Land Development and Transportation Committee Staff Report March 13, 2025

Case No:	25-DDP-0007
Project Name:	Beulah Crossings Townhomes
Location:	6803 Beulah Church Road
Applicant:	Beulah Church Road LLC
Representative:	Land Design & Development
Jurisdiction:	Louisville Metro
Council District:	23 – Jeff Hudson
Case Manager:	Ethan Lett, AICP, Planner I

- **Detailed District Development Plan** with binding elements

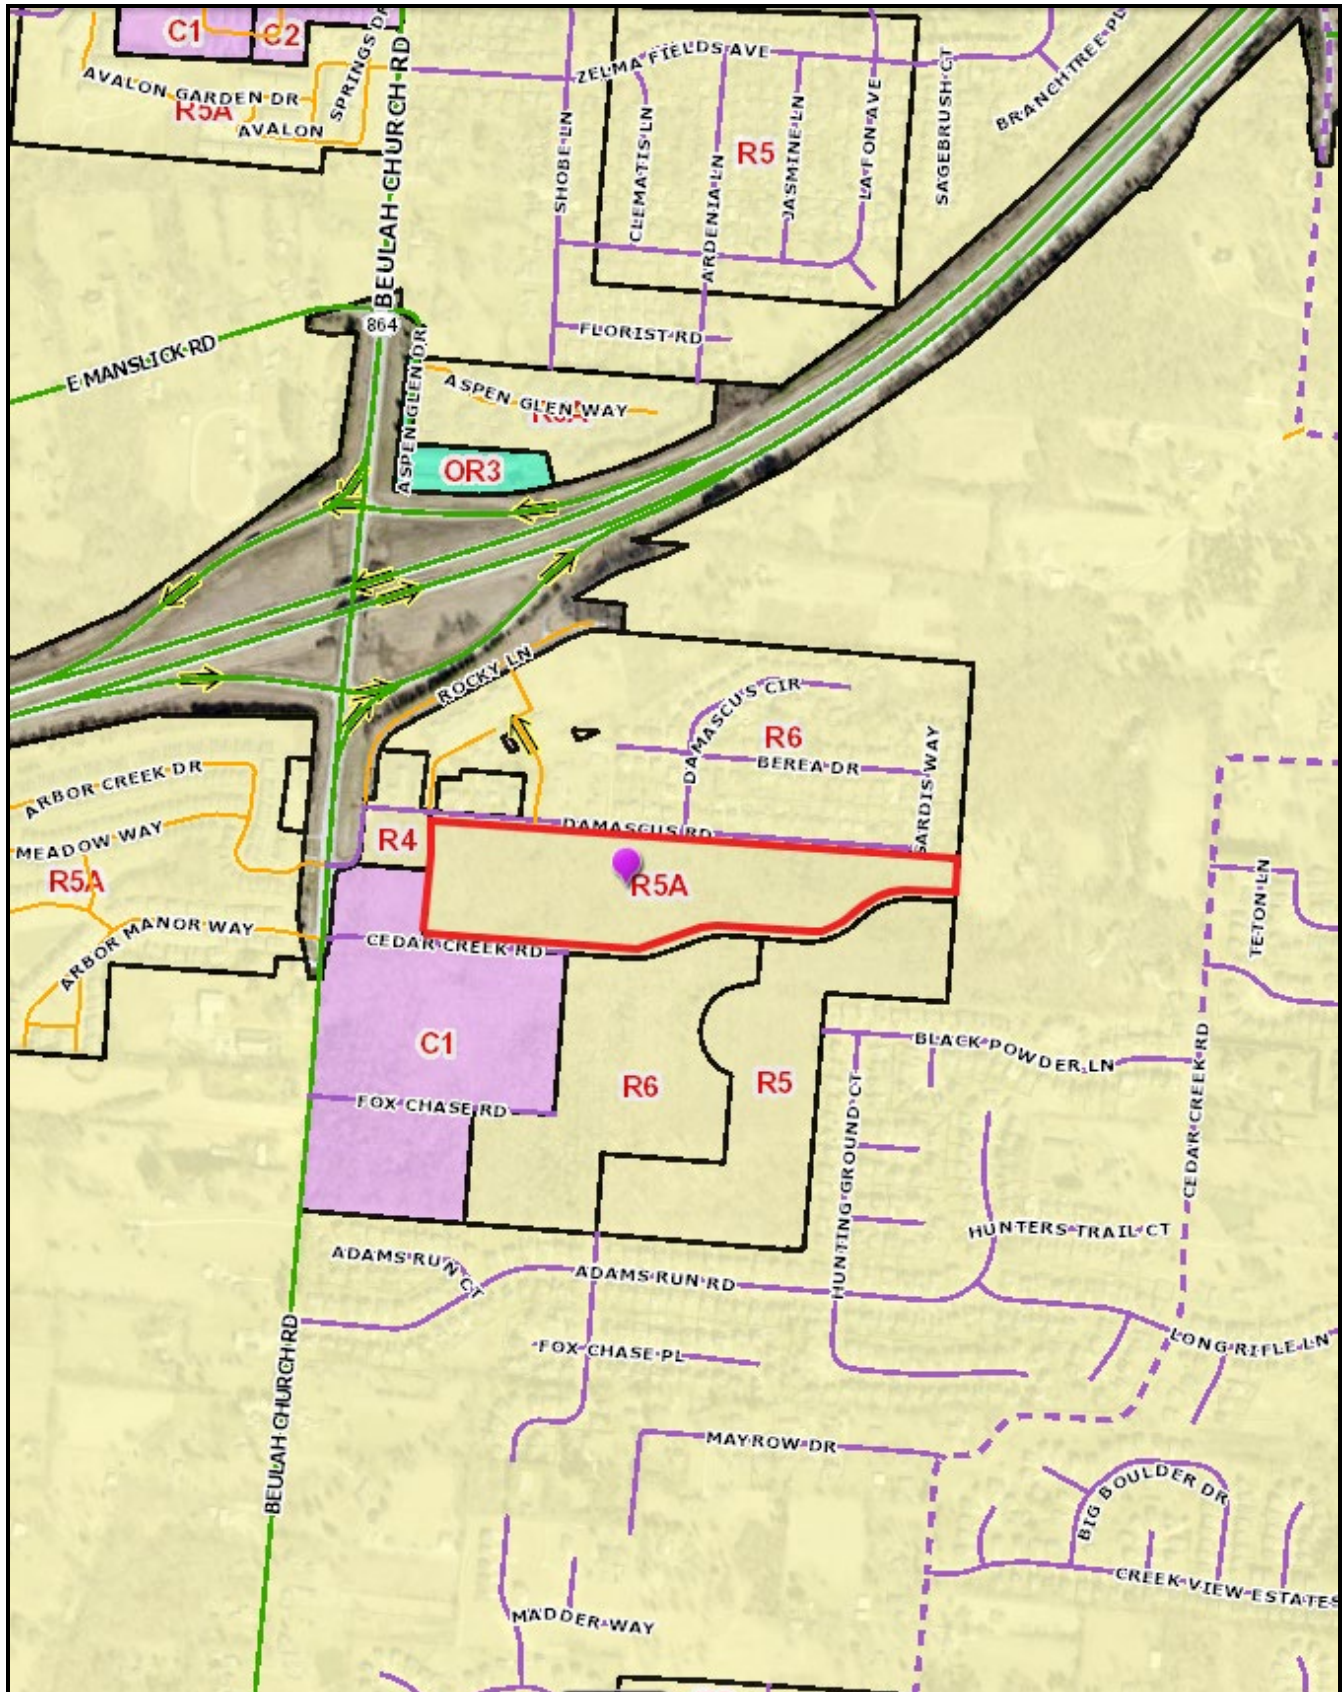
Ethan, I have concerns with the layout. There is no longer a tree buffer along the Damascus Rd. across from my property 8403 Damascus Rd. The original proposals said that there would be a 100ft of tree buffer all along our street. It looks as if there is a cut out for drainage almost directly across from my property. I was ok with original plans because I was going to have a buffer and not have to look at the development. Now that is gone? Another concern for me, our street already collects water whenever it rains. Has the developer taken into consideration the drainage and traffic issues this development is going to create for the surrounding neighborhoods?
